Oakdale West Estate Modification 6

Changes to the building design and layout within the approved Concept and Stage 1 development, timing of Estate Road 8 construction and vegetation management area

State Significant Development Modification Assessment (SSD-7348-MOD-6)

March 2021

Figure 4 | Proposed OWE Concept Proposal under SSD-7348 MOD 6

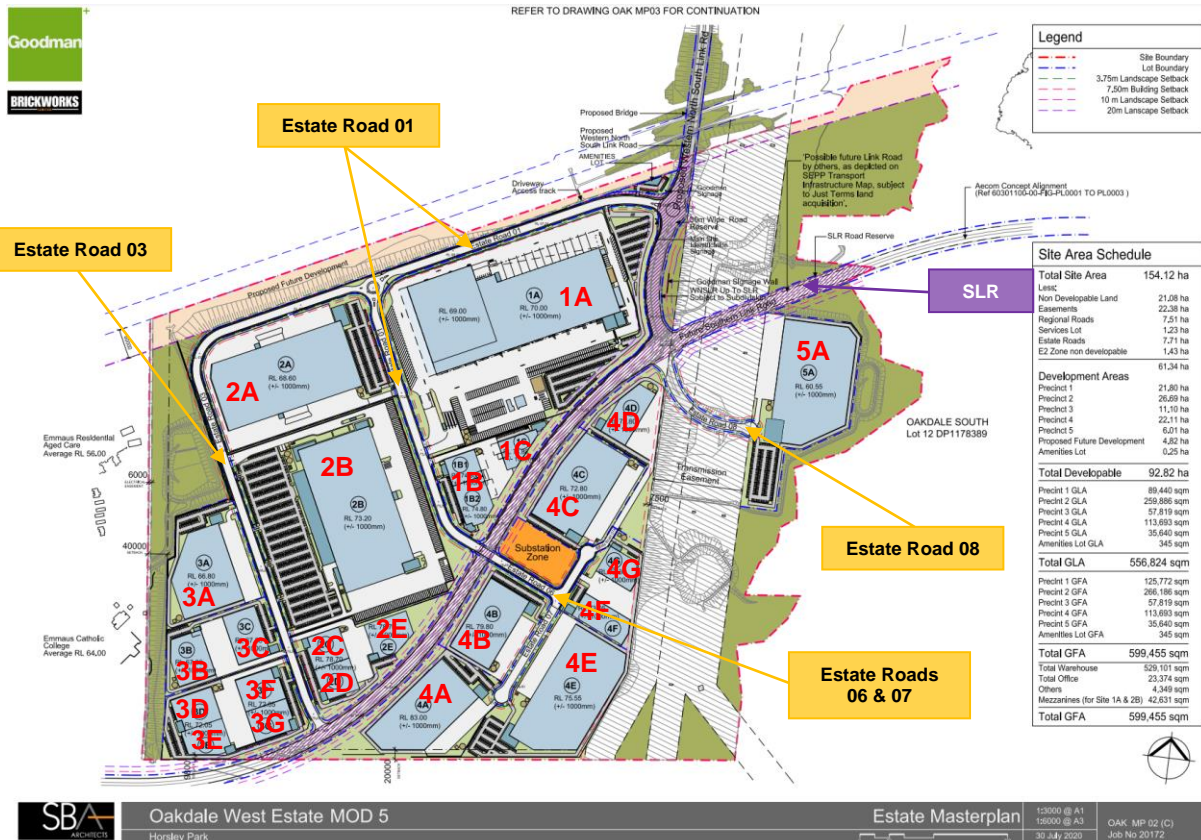
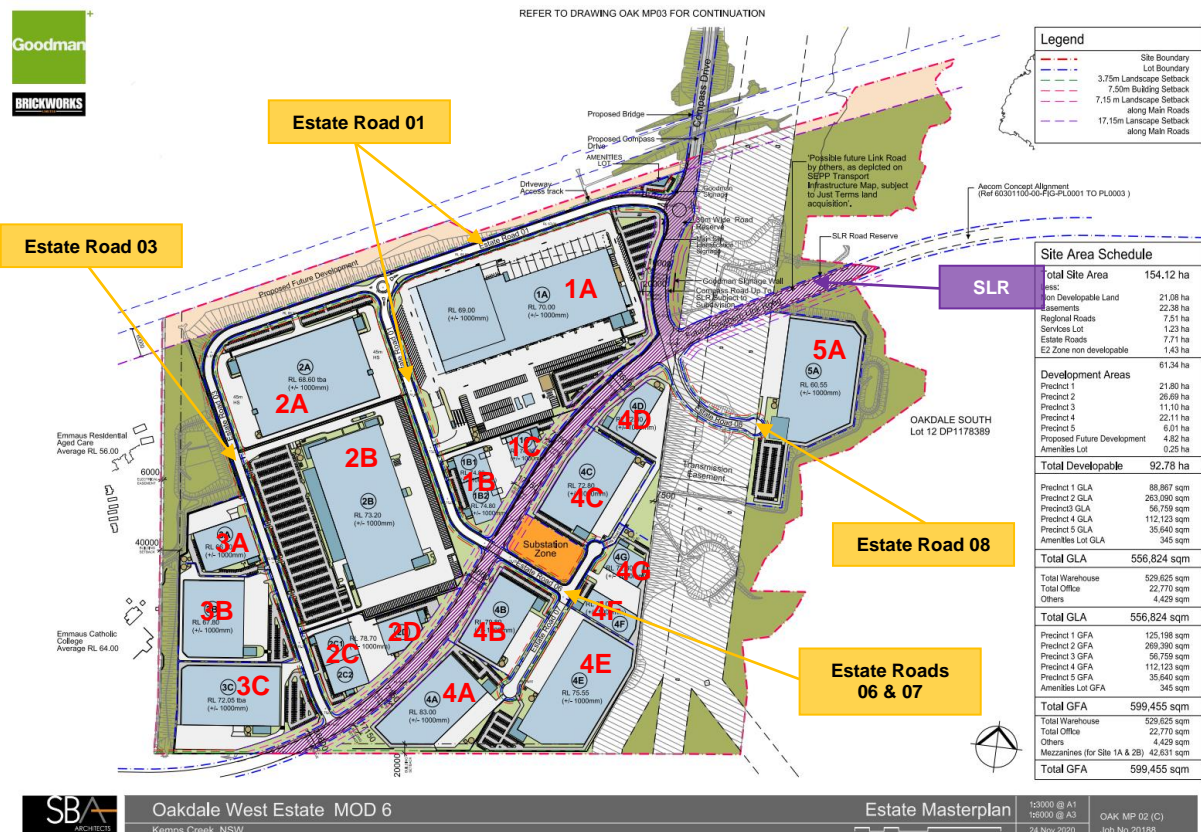
- revisions to the layouts of Buildings 1B and 1C under the Stage 1 development, but do not include changes to setbacks, building heights or access
- increase in height of Building 2A from 15 m to 18 m, with the maximum approved ridge height to be increased from 13.7 m to 14.9 m. The proposed height increase is required to enable installation of rooftop plant, solar panels and equipment

- minor alterations to building form and layout of Buildings 2A, 2C and 2D within the Concept Masterplan, resulting from detailed design development
- changes to buildings in Precinct 3 within the Concept Masterplan, including a reduction from five warehouses to three. However, the building layouts and footprints within Precinct 3 are not approved under SSD 7348, in accordance with Conditions B3 and B9(c) and will be subject to separate assessment under a future development application

The Department concludes there will not be any additional significant visual impacts from the proposed modifications and the changes to building design maintain compliance with the development controls of the consent for SSD 7348, as modified. The updated landscape plans reflect the amended building layouts, while maintaining the intention of the previously approved landscaping scheme for the site and appearance of the development. An assessment of the detailed design of Buildings 2A, 2C and 2D and the buildings in Precinct 3 will be undertaken under separate development applications. As such, no amendment to landscaping or visual amenity conditions is recommended.

Figure 7 | Comparison of photomontage from Viewpoint 1, west of the site looking towards Buildings 2A and 2B, under MOD 3 (top) and MOD 6 (bottom)

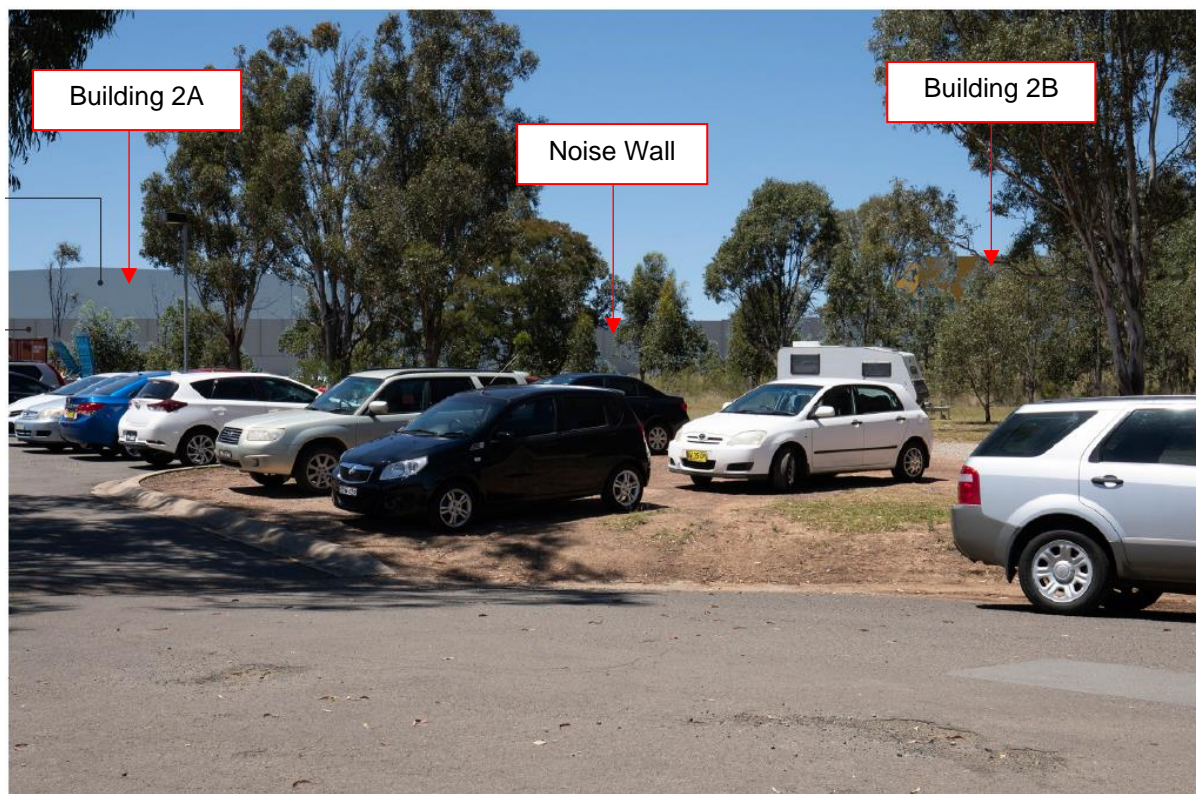
The modification application was supported by an amended Visual Impact Assessment (VIA), which updated the assessment of visual impacts on adjoining receivers undertaken for amendments to the development under MOD 3. The VIA considered views of the modified development, including the increased height of Building 2A, from previously assessed viewpoints on the western and southern site boundaries. The VIA concluded that the increase to the height of Building 2A results in a minimal change in the viewer's perception and does not change the impact rating (see **Figure 7**). Overall, the VIA found the changes to be largely visually imperceptible from the previously assessed viewpoints and do not significantly change the overall quantum of view, scale and magnitudes for the viewpoints.

The Department considers the proposed modifications to building design and layout to be relatively minor and in keeping with the appearance of the development as previously approved. The buildings maintain the established setbacks from external and internal boundaries and roads, and the visual

Figure 8 | Comparison of approved (left) and proposed (right) VMP extent of works shown in dark green

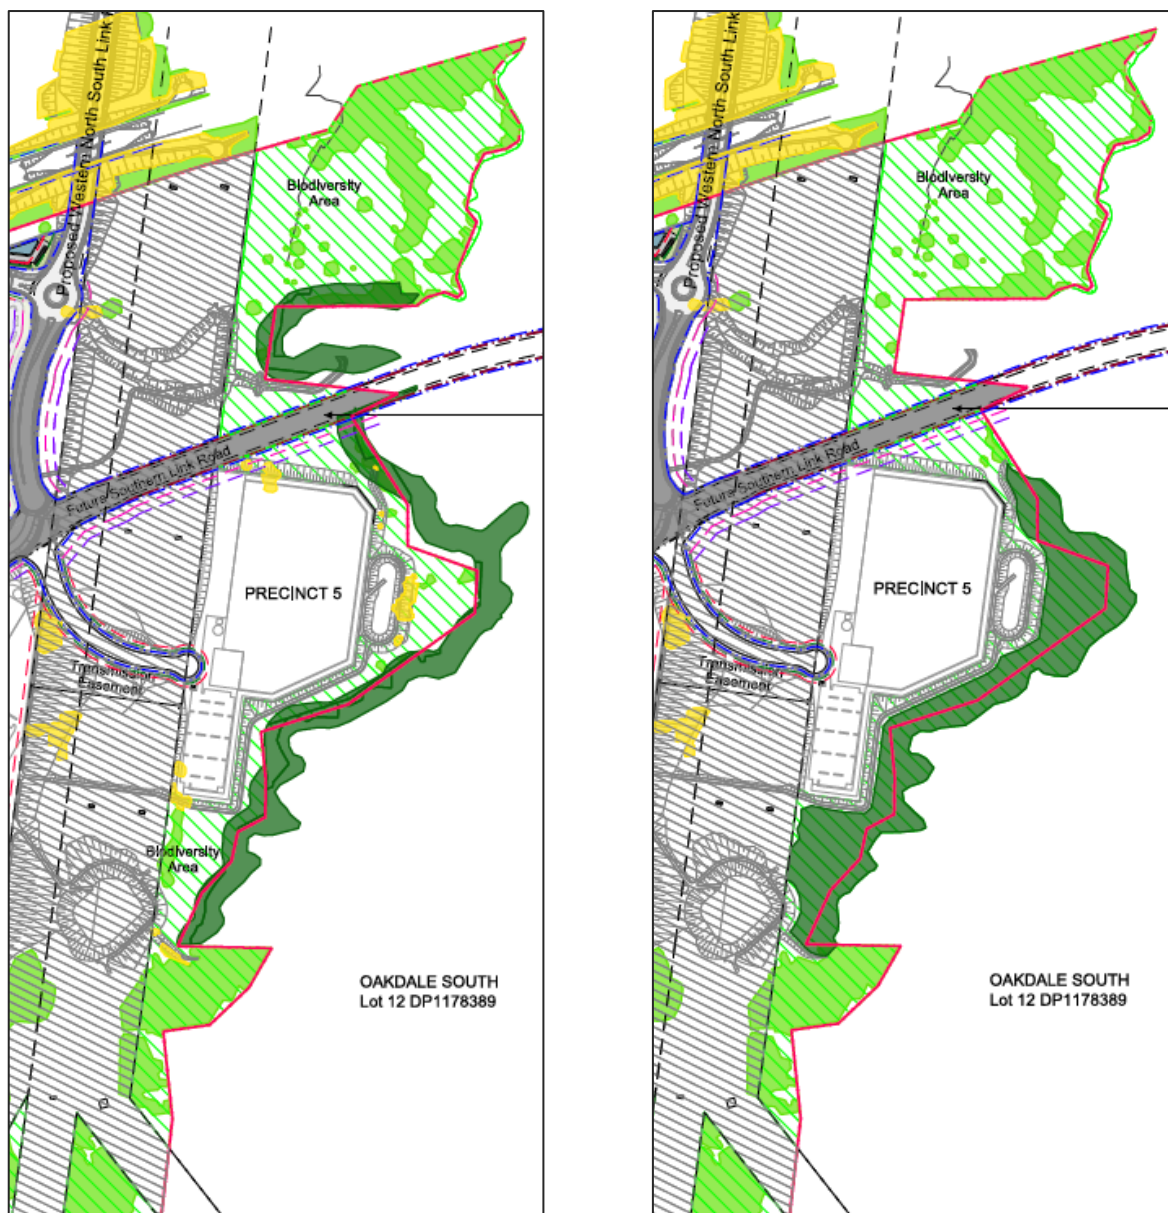
The Applicant proposes to remove a section of the VMP area from the northern side of the future Southern Link Road (SLR), which currently dissects the existing VMP corridor (see **Figure 8**) and increase the size of the southern section of the VMP area. The Applicant maintains the modified corridor would:

- provide a wider riparian zone connecting isolated patches of retained vegetation
- remove locations adjacent to the SLR and reduce disturbance from its future construction
- provide unimpeded contractor access to the VMP area from the Oakdale South Industrial Estate (to the east of the site) while construction activities are still being undertaken within the site.

The Department considers the proposed amendment to the VMP area would result in an improved outcome given the revised layout is no longer intersected by the SLR road reserve and connects areas of retained vegetation, while also ensuring continued access to the VMP area for revegetation and maintenance works via the Oakdale South Estate (also owned by the Applicant). The increased VMP area would result in the restoration of an additional 2,822 m² of land and ensure the land included in the VMP area is not disturbed by the future construction of the SLR. In accordance with Conditions D133 and D134 of SSD 7348, the Applicant is required to review and update the VMP to the satisfaction of the Planning Secretary following approval of a modification. The updated VMP will require separate consideration and endorsement following approval of the modification. The Department concludes the proposed modified, larger VMP area would maintain the biodiversity outcome as previously approved. It is recommended that the plans referenced in the consent be updated to reflect the modified layout and the Mitigation Measures in Appendix 7 be updated to reflect the VMP and previous modifications.
